Service Note

Product	Description:	Service note no.
BG250 / BH250	Hissing noise from power supply	SNo-T0184

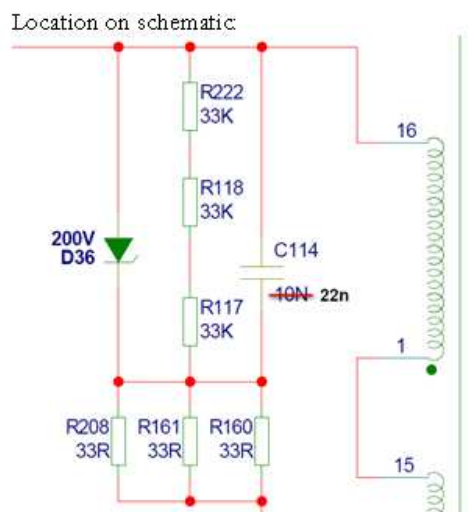
Some of the power supplies in the BG/BH250 models tend to make a hissing sound.

This is caused by a ceramic capacitor C114 of value 10nF/1000V placed in the primary switch snubber circuit.

Replace this:

With this:

To reduce the hissing noise level, C114 must be replaced by a film capacitor with the value of 22nF/400V (7E20404711). Affected production BOM's are all revision from EAA to EAE. The change has been implemented from version P18114-EAF.
